CERTIFICATE OF APPROPRIATENESS

Property: Lot 9, Block 132, Norhill Neighborhood Subdivision. The property includes an historic 1,235 sq. ft., one-story wood single-family residence and detached garage situated on a 5,000 square foot (50' x 100') interior lot.

Proposal: Alteration – Rear Addition, Garage, and Carport
Addition – 724 sq. ft., with a 167 sq. ft. cover porch

FIRST FLOOR PLAN

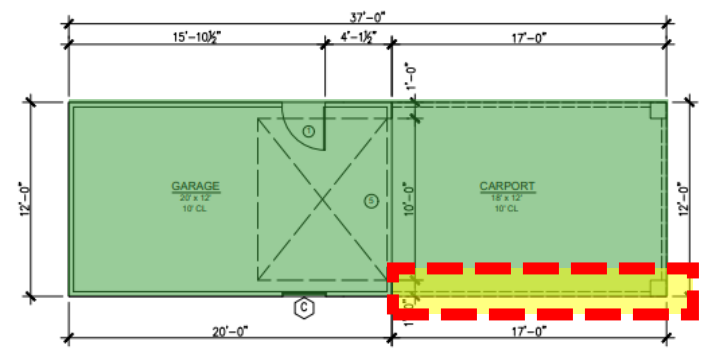
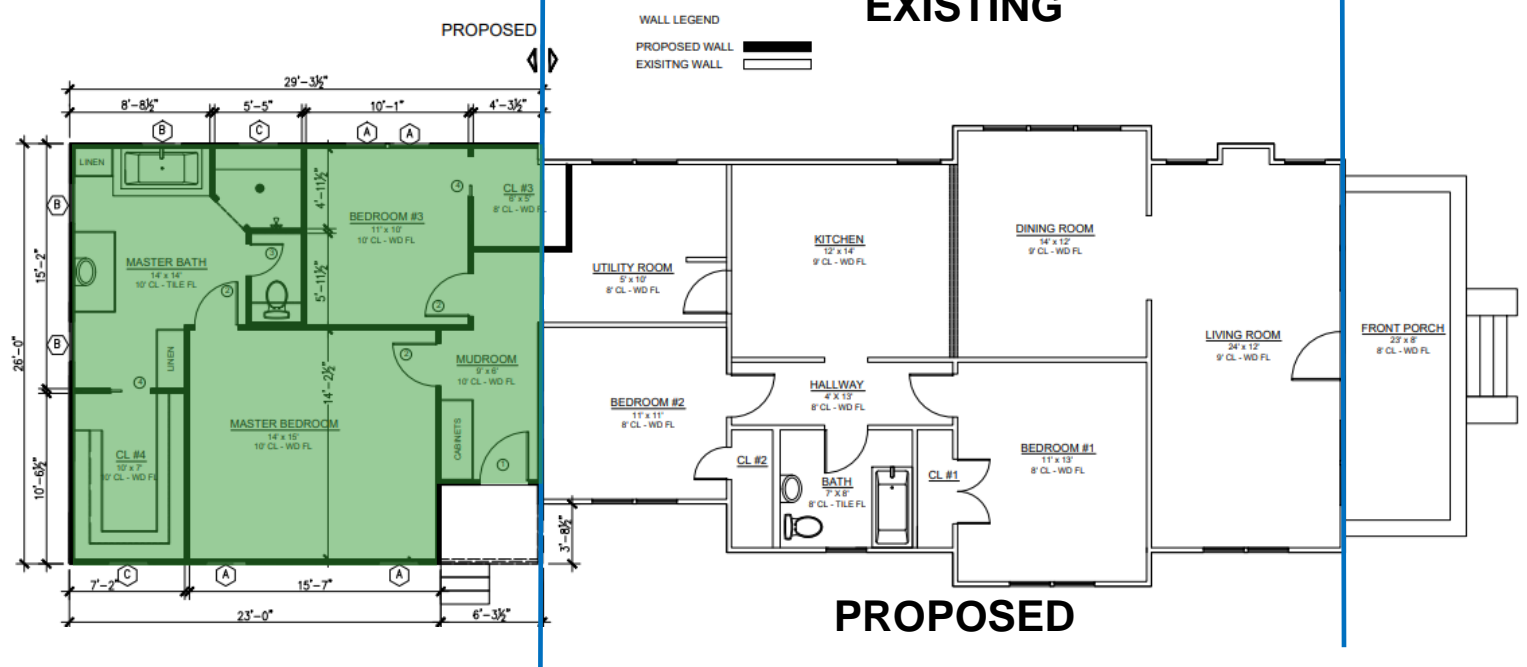
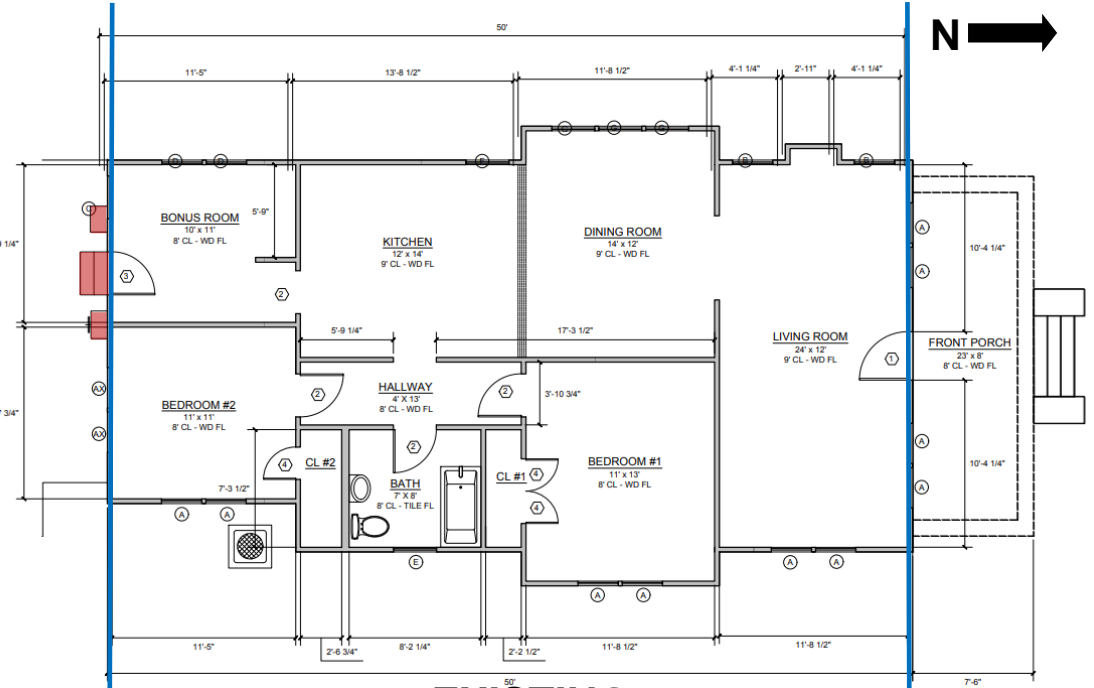
Approval with conditions: Proposed Carport East elevation, construct solid wall, 1 hour fire-rated, of smooth cementitious board.

**PROPOSED
EAST ELEVATION**
1/4" - 1' - 0"

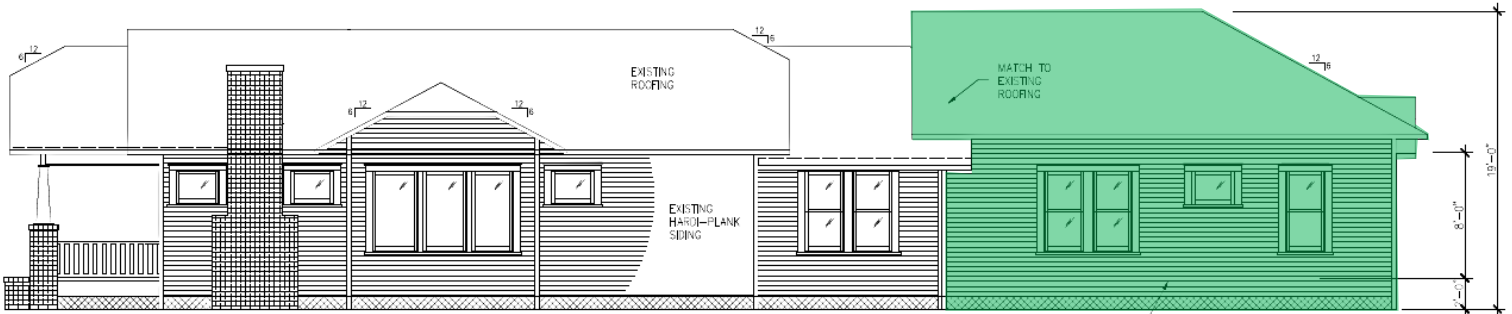
Recommendation: Approval with conditions: Proposed Carport East elevation, construct solid wall, 1 hour fire-rated of smooth cementitious board.

Approval with conditions: Proposed Carport East elevation, construct solid wall, 1 hour fire-rated, of smooth cementitious board.
